SUBJECT 200M GAL DE, 36"Ø, 108.62' LCL
DATE 6-1-71
CHECKED BY P.W.D.

MODIFICATIONS TO ANCHORS AND BASE PLATES FOR CONTRACT # 20603 DUE TO ANCHORS

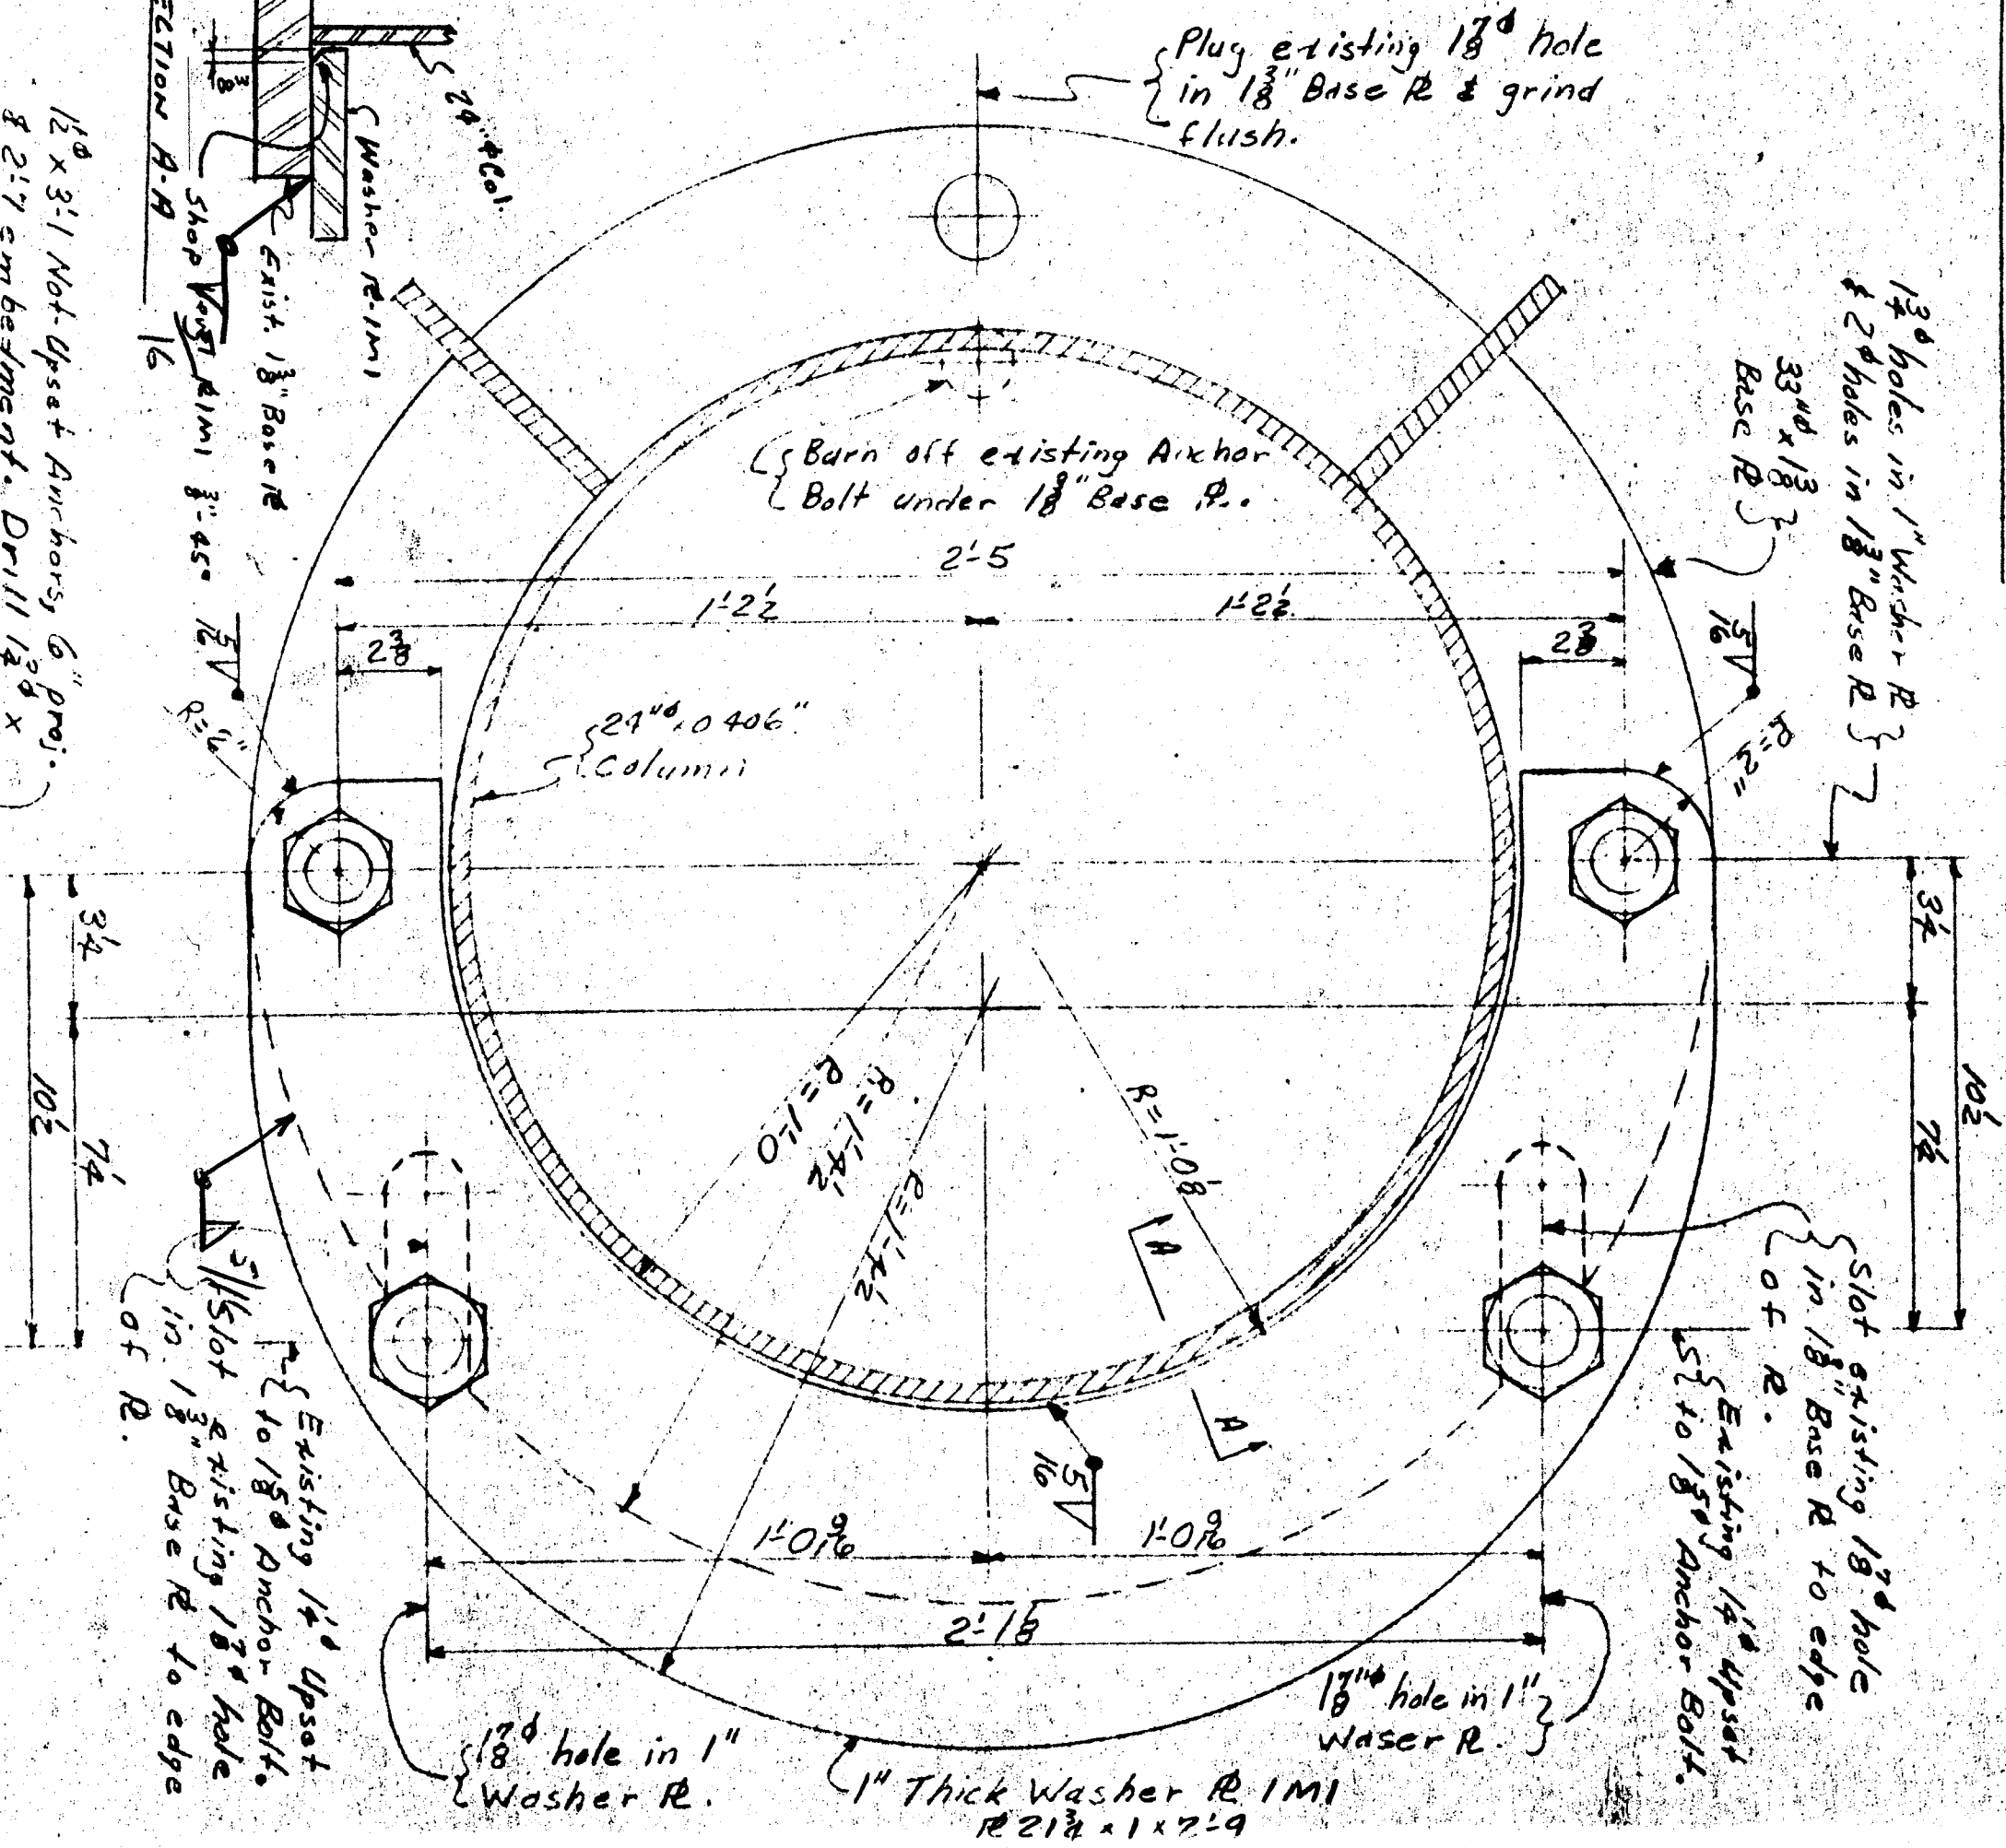
12 x 3'-1 Not-Upset Anchors, 6" proj.
@ 2'-7 embedment. Drill 12" x
2'7 holes in concrete. Holes to
be as nearly vertical as possible.
Bond Anchors in holes with
Colma-Dur LV epoxy adhesive
as made by Sika Chemical Corp.
or approved equal. (Furn. by Sear) -

$R + 0 \notin NE \text{ Column} = 27'93''$
 $R + 0 \notin SE \& SW \text{ Columns} = 27'94''$
 $R + 0 \notin NW \text{ Column} = 27'104''$

APPROVED AS CORRECTED
SUBJECT TO CONTRACT REQUIREMENTS
